**Analyses of Groundwater Flow, Contaminant Fate and Transport,** and Distribution of Drinking Water at Tarawa Terrace and Vicinity, U.S. Marine Corps Base Camp Lejeune, North Carolina: **Historical Reconstruction and Present-Day Conditions**

Response to the Department of the Navy's Letter on: **Assessment of ATSDR Water Modeling for Tarawa Terrace**

# RESPONSE TO THE DEPARTMENT OF THE NAVY'S LETTER ON ASSESSMENT OF ATSDR WATER MODELING FOR TARAWA TERRACE

ATTACHMENT 6: OBSERVED AND SIMULATED WATER LEVELS, MODEL LAYER 1, AND CALIBRATION TARGETS FOR (A) PREDEVELOPMENT (STEADY STATE) CONDITIONS AND (B) TRANSIENT CONDITIONS, 1951–1994, TARAWA TERRACE AND VICINITY, U.S. MARINE CORPS BASE CAMP LEJEUNE, NORTH CAROLINA (FROM MASLIA ET AL. 2007B, FIGURE A10)

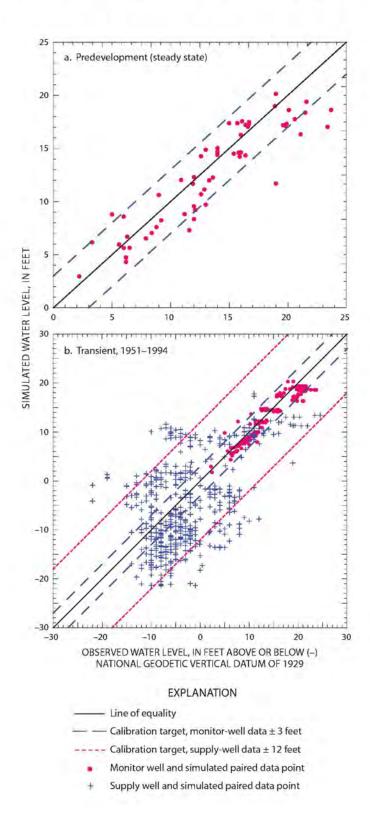
For Tarawa Terrace groundwater, the difference between observed and simulated elevations is 5 to 10 feet at many times during the 1970's and 1980's. This is a significant disparity because the total change in groundwater elevation from the source area to the receptor wells is approximately 10 to 12 feet.

This DON approach to evaluating model calibration applies a generalized "rule of thumb" to the Tarawa Terrace groundwater-flow models and is possibly based on wording found in ASTM Guide D5981-96, Standard Guide for Calibrating a Ground-Water Flow Model Application, (ASTM 1996, section 6.4.1): "the acceptable residual should be a small fraction of the difference between the highest and lowest heads across the site." ATSDR is not in agreement with this approach to evaluate model calibration. A careful review of ASTM D5981-96 in its entirety indicates that the DON's comment, as stated, is totally removed from the context of Section 6 of the ASTM Standard Guide as well as the context of the accuracy of field data used to calibrate the Tarawa Terrace groundwater-flow model, as described in the Chapter C report (Faye and Valenzuela 2007). For example, in Section 6.4, ASTM D5981-96 states: "the magnitude of the acceptable residual depends partly upon the magnitude of the error of the measurement or the estimate of the calibration target and partly upon the degree of accuracy and precision required of the model's prediction." Furthermore, Note 2 of ASTM D5981-96 states: "Acceptable residuals may differ for different hydraulic head calibration targets within a particular model. This may be due to different errors in measurement." The Tarawa Terrace Chapter C report (Faye and Valenzuela 2007, p. C24) provides a comprehensive discussion of water-level measurement errors arising from the use of airlines and pressure gages to measure water levels. Faye and Valenzuela also point out that this is consistent with the discussions of LeGrand (1959) who described problems associated with the use of airlines to measure water levels at Camp Lejeune as far back as 1959. As pointed out in Faye and Valenzuela (2007, p. C24): "Typically, reported water levels [at supply wells] vary in excess of 20 ft during the period of measurement, and frequently 10 ft or more from month to month.... Such variability also may indicate leaking or damaged airlines or pressure gages."

Faye and Valenzuela (2007, p. C24) also provide detailed discussions as to the rationale for selecting two calibration target ranges for the transient groundwater-flow model. At wells where water-level measurements were obtained using airlines and pressure gages, the calibration target was selected as an absolute difference of 12 ft between simulated and measured water levels. This target was based on well-known disadvantages of using pressure gages and airlines to obtain accurate water-level measurements. Where water-level measurements were obtained using the more highly accurate tapes and similar devices at monitor wells, the calibration target was selected as an absolute difference of 3 ft between simulated and measured water levels. This target was based on the least accurate of these water-level measurements where topographic maps were used to estimate the altitude of a measuring point.

Evaluating model calibration using the "rule of thumb," as the DON has suggested, also assumes that no other information is available to determine calibration targets. When information is available, such as direct knowledge of methods of water-level measurements and information characterizing the measurement device(s), the calibration targets should be based on these data, not on a "rule of thumb." Faye and Valenzuela (2007) provide detailed listings of measured water levels in supply and monitor wells throughout Tarawa Terrace (Appendix C5).
